# Outpatient Surgery Renovations RFI's

Project Title  
MARTINSBURG VA MEDICAL CENTER  
OUTPATIENT SURGERY RENOVATIONS  
Location  
MARTINSBURG, WV  
Date  
03-04-2011  
Checked  
JEG  
Drawn  
MLS

Project Number  
- 613-103  
Building Number  
- 500  
Drawing Number  
ES-104

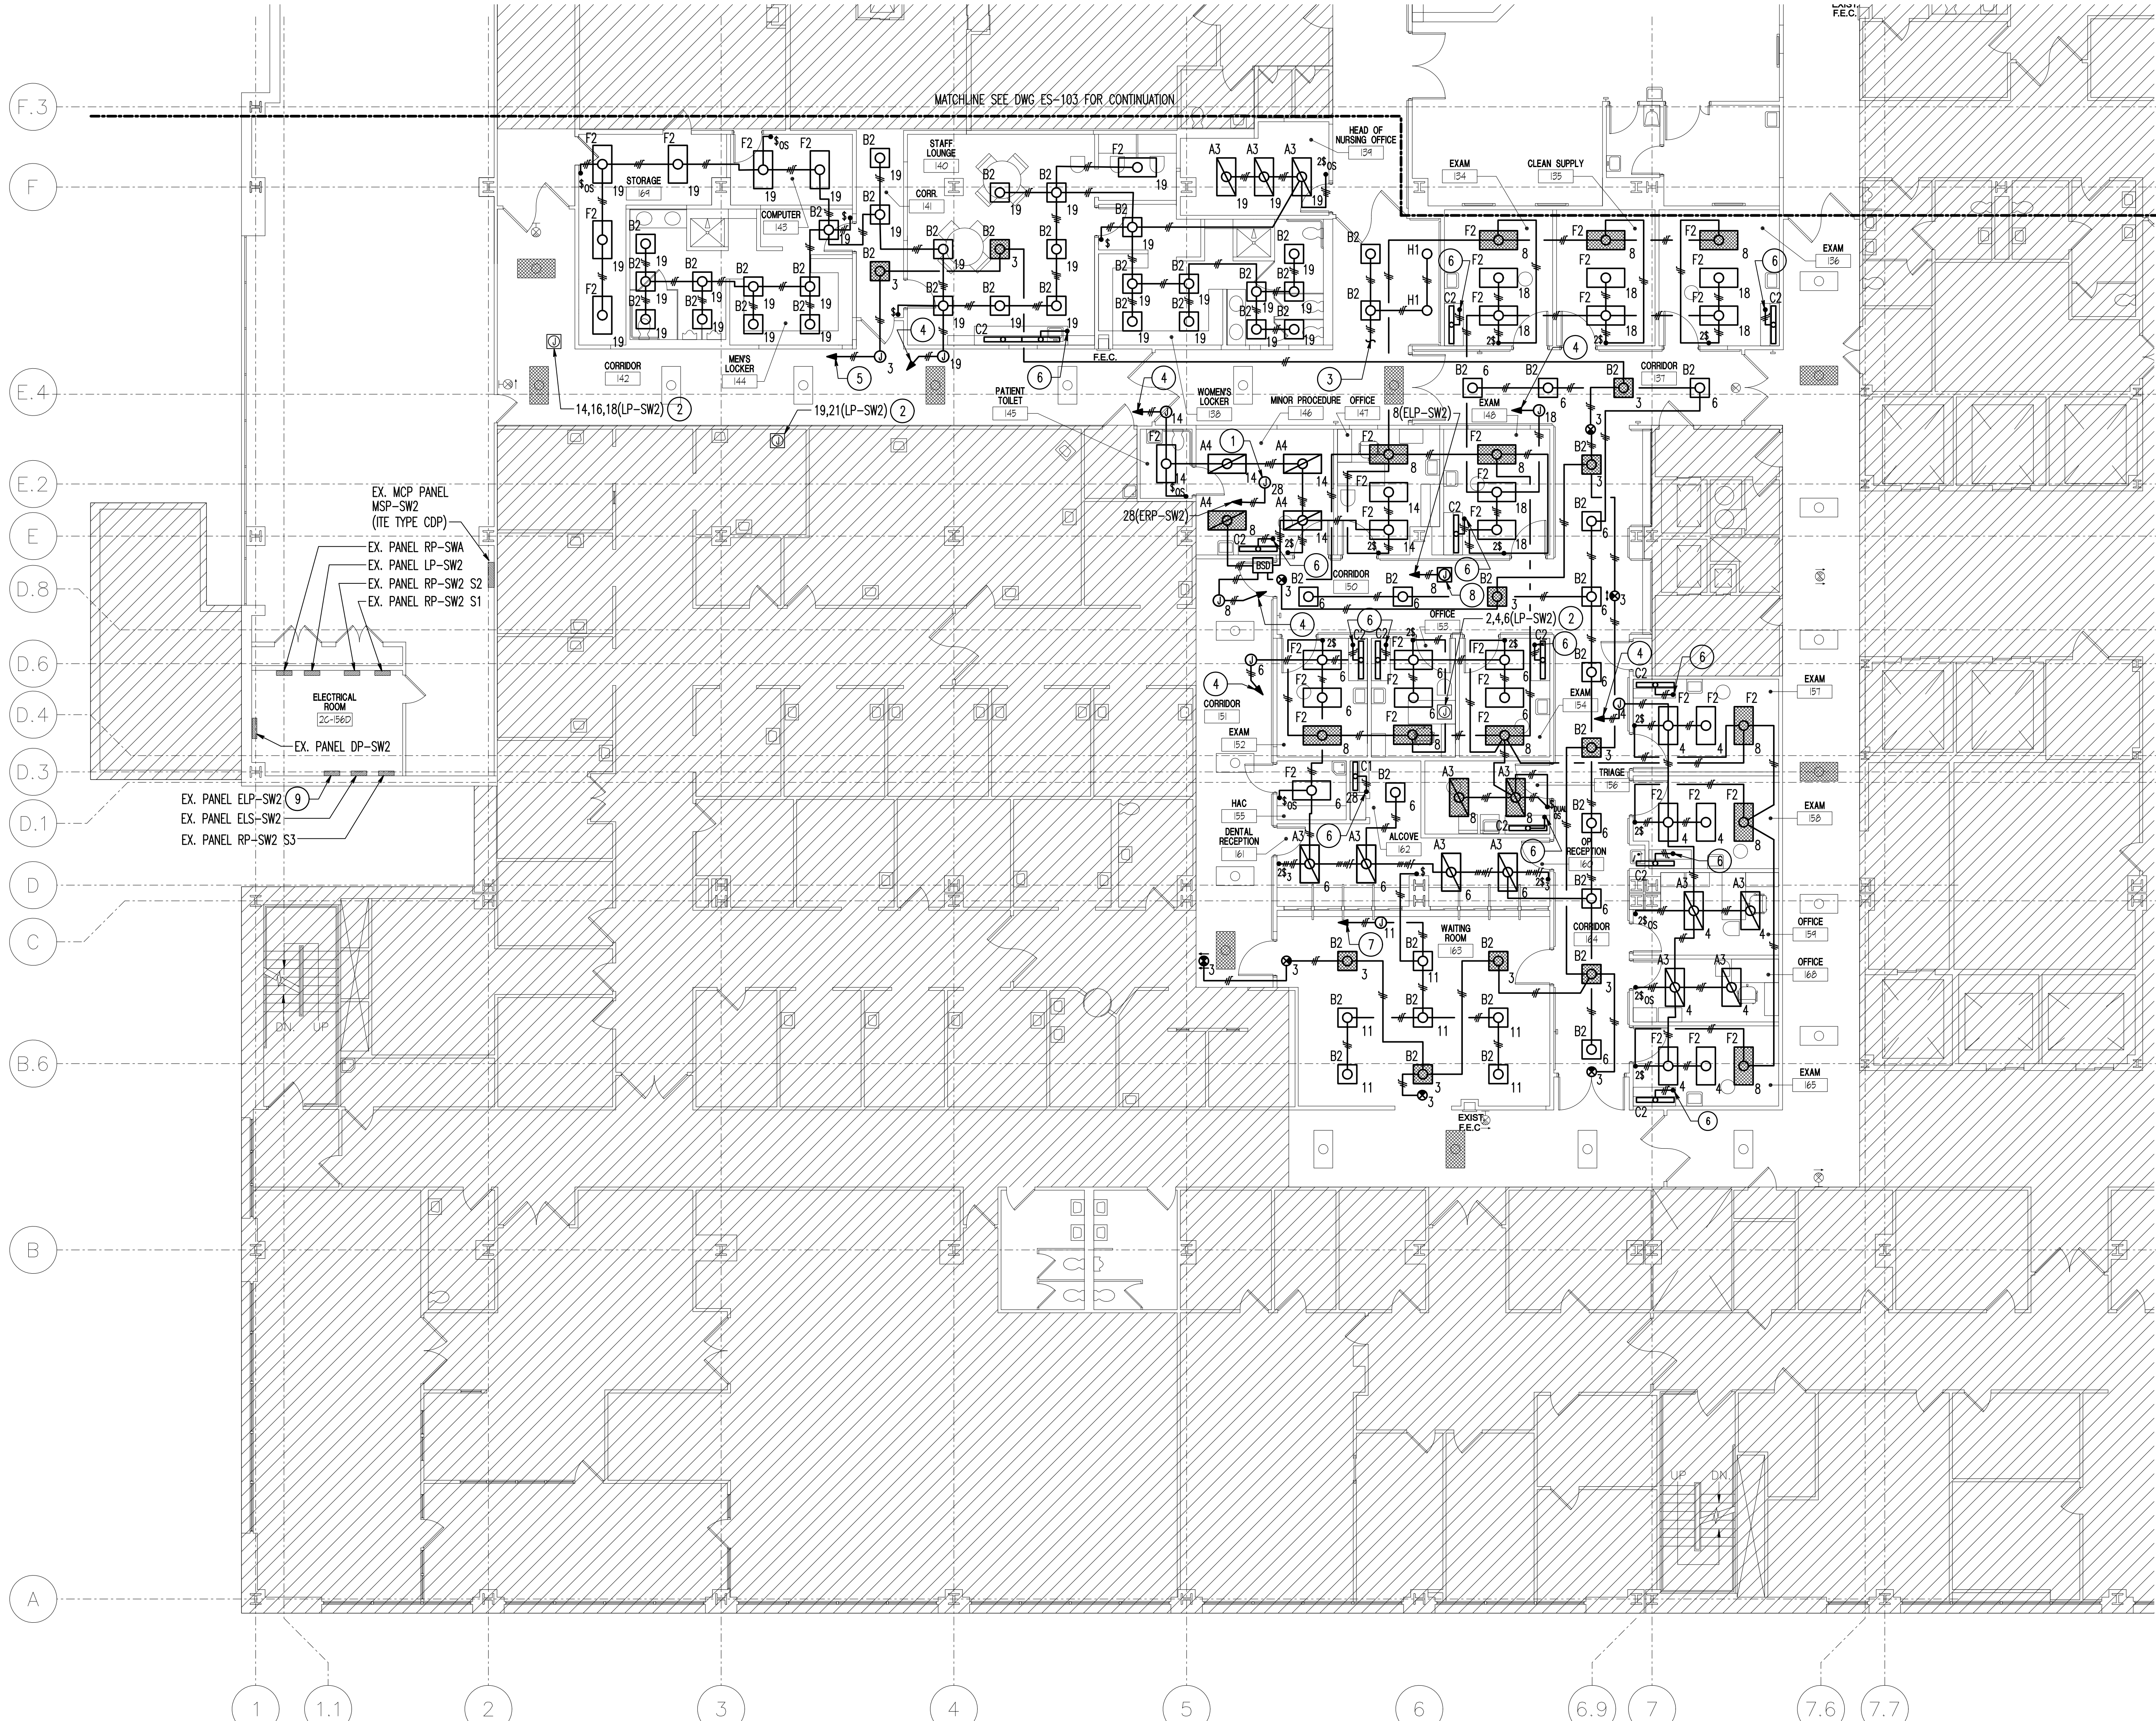
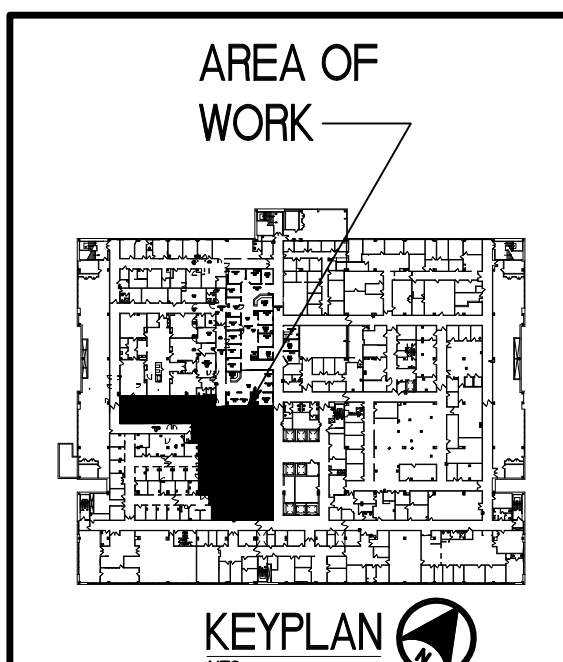
18 Drawing ES-103 Special Note 1 and drawing ES-104 Special Note 1 calls for a Junction box for OR Light. Are we just providing power to a junction box and light being purchased and installed by others? **The light is purchased and installed by the contractor. OR Light is by Steris, Dual Head Amsco Examiner 10. See attached Cut Sheet.**

Most of the rooms do not have emergency powered general lighting, however PACU 129 does have a couple emergency powered lights is that adequate coverage for that room, or should all Emergency receptacles be self-illuminated type. **The majority of the rooms with emergency receptacles have emergency lighting, but for the rooms where there are emergency receptacles and no emergency lights, the self-illuminated receptacles are required. See attached updated lighting plan.**

Project Number  
- 613-103  
Building Number  
- 500  
Drawing Number  
ES-103

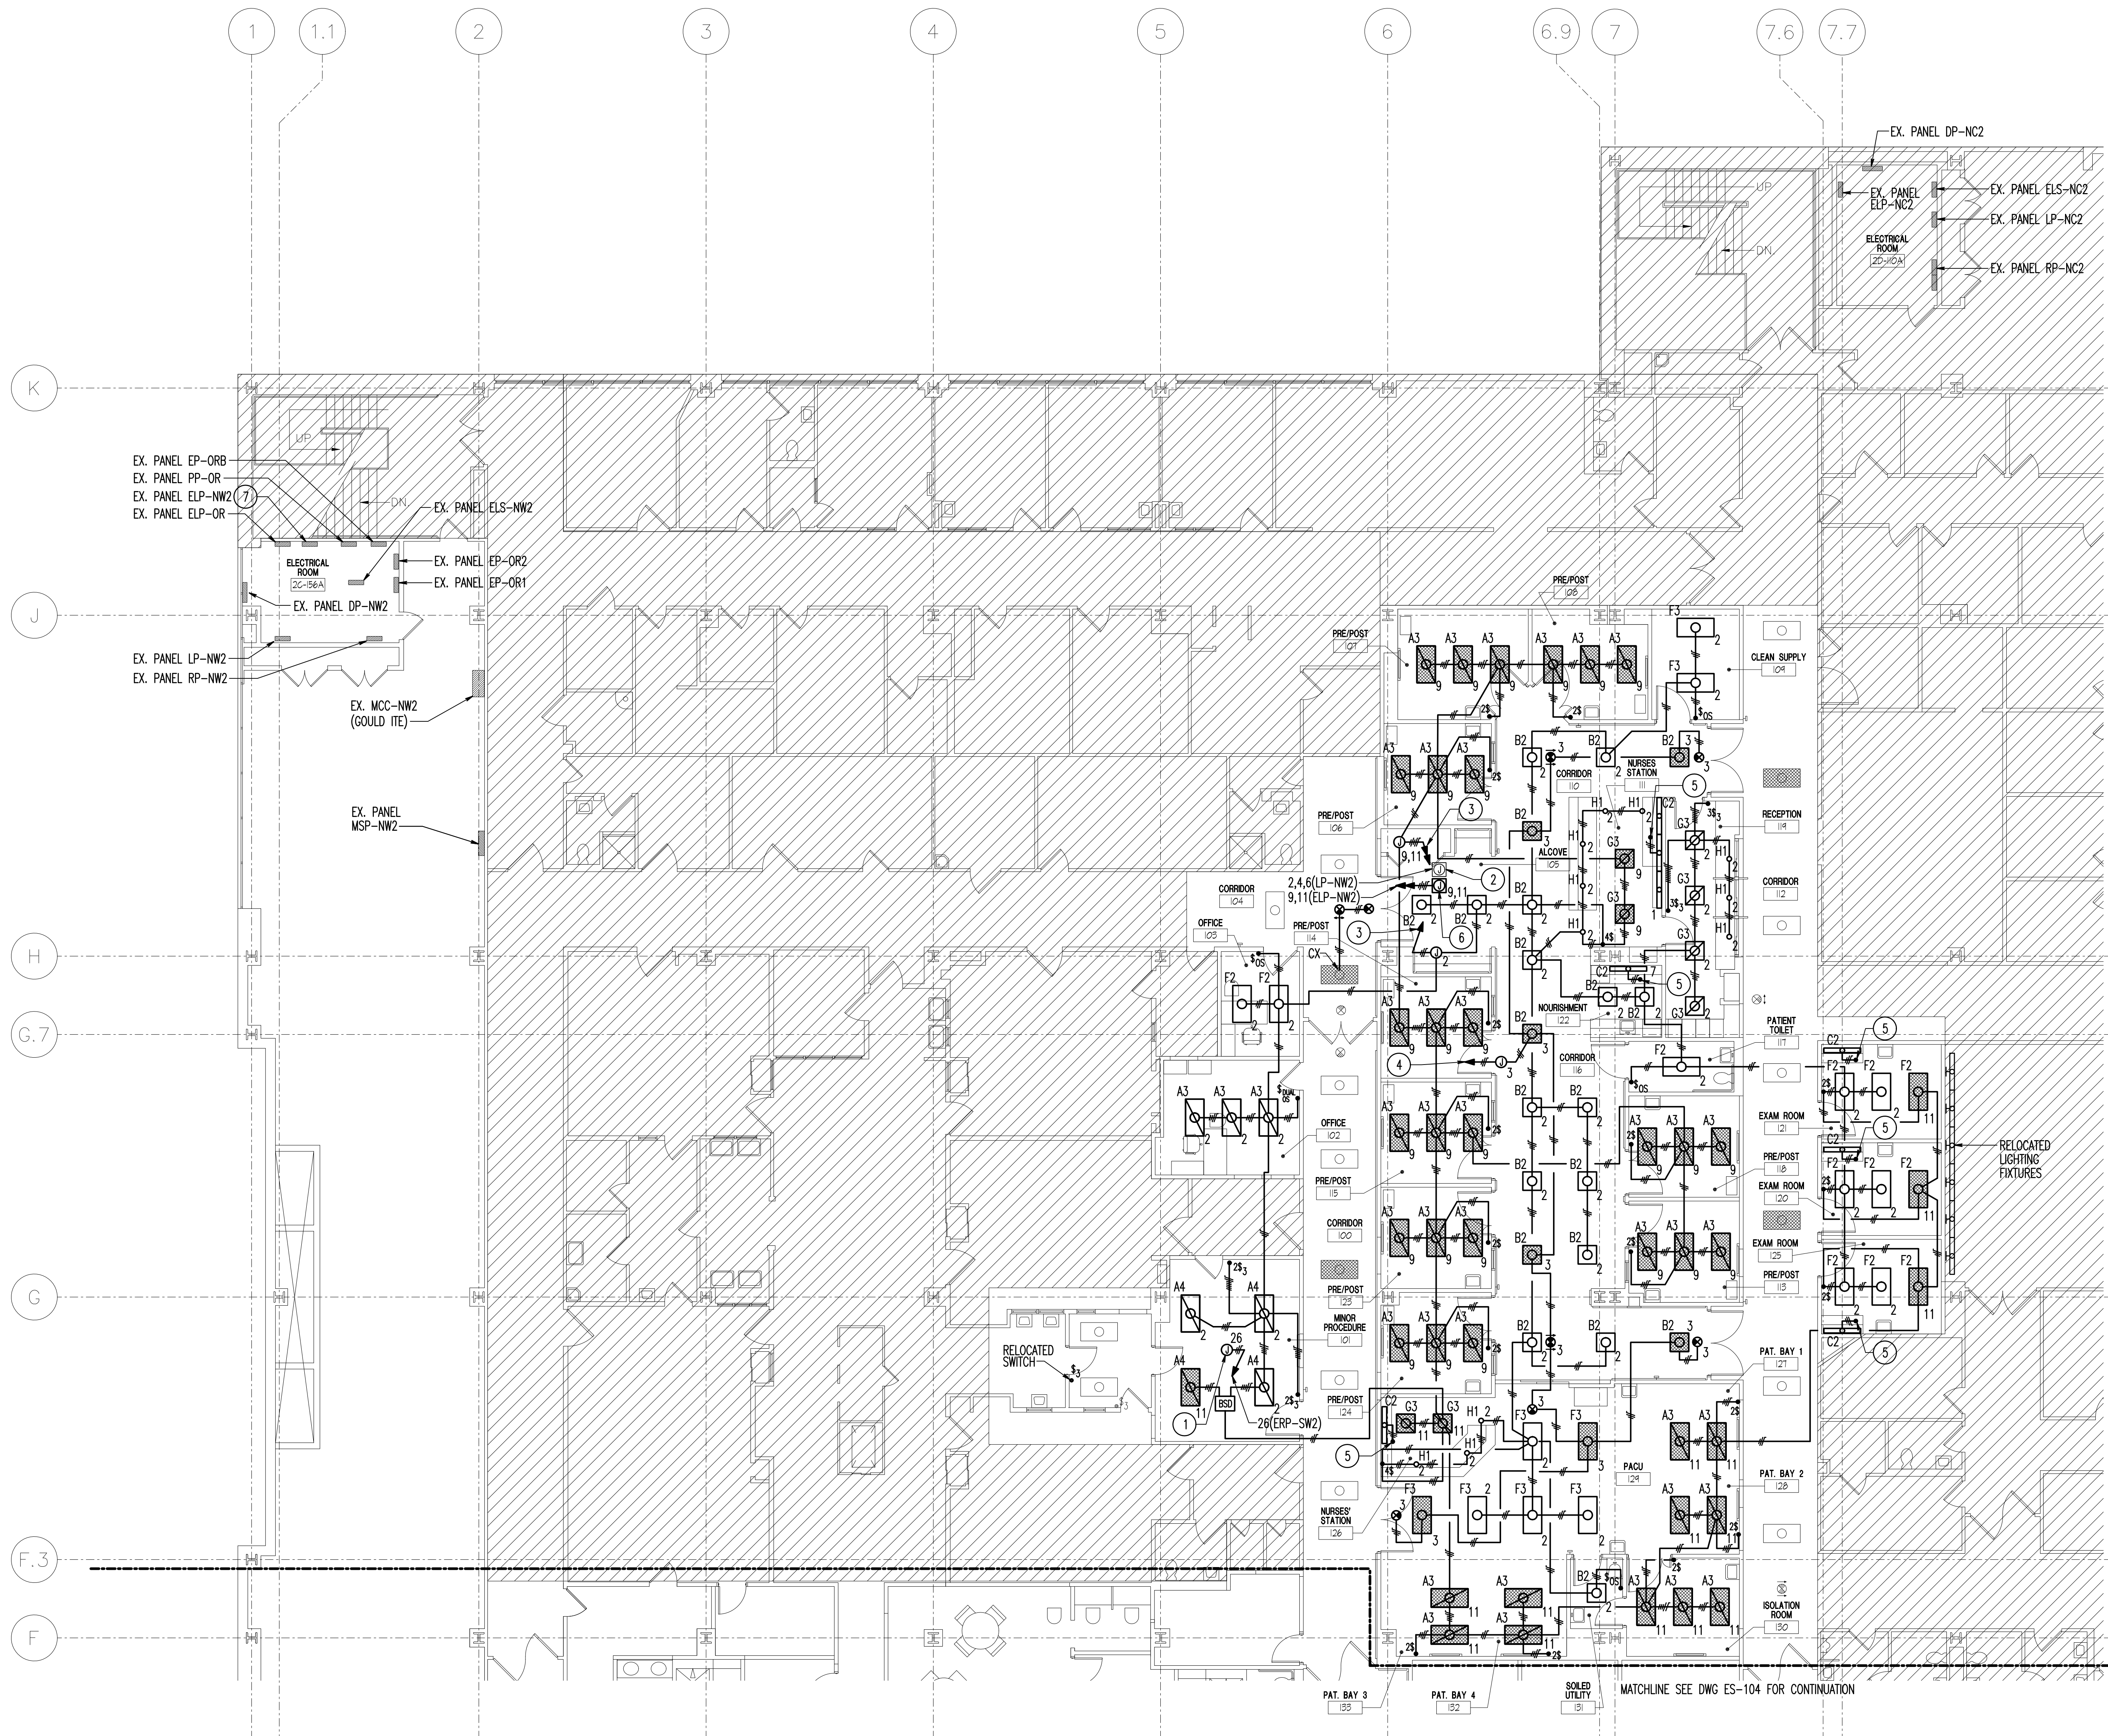
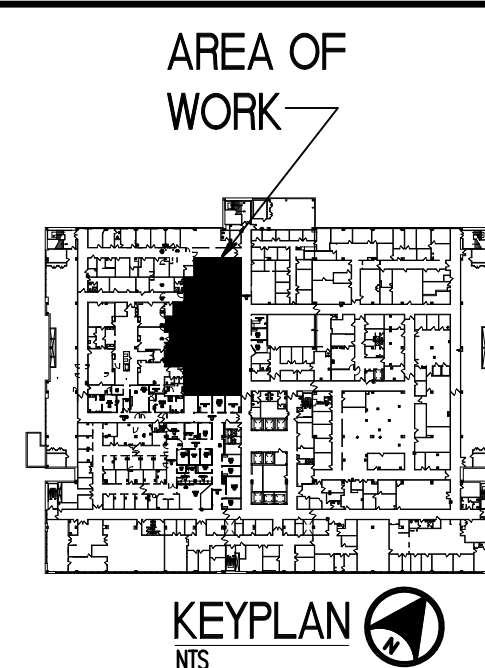
17 Drawing ES-103 Shows the majority of the lighting being on circuit 2 and 6 then goes to note 3 stating "To floor mounted junction box in interstitial space." It does not give the panel. Then there is note 2 that states "existing floor mounted junction box in interstitial space." Which shows LP-NW2 2,4,6. The same situation is also done in several locations on Drawing ES-104. They show circuit 18 going into the interstitial space but no panel. In another location they show a junction box located in the interstitial with labeled LP-SW2 14,16,18. Is it the

intent that circuit 18 is to go there? Please clarify. The same scenario has been done on ES-105 and ES-106. **For the above example, there is an existing floor mounted junction box in the interstitial space above the renovation area with circuits 2,4 and 6 from panel LP-NW2. The lighting circuit 2 is indicated to go to the floor mounted junction box in interstitial space. It is the intent for the lights to be fed from circuit 2 in panel LP-NW2. This is typical.**
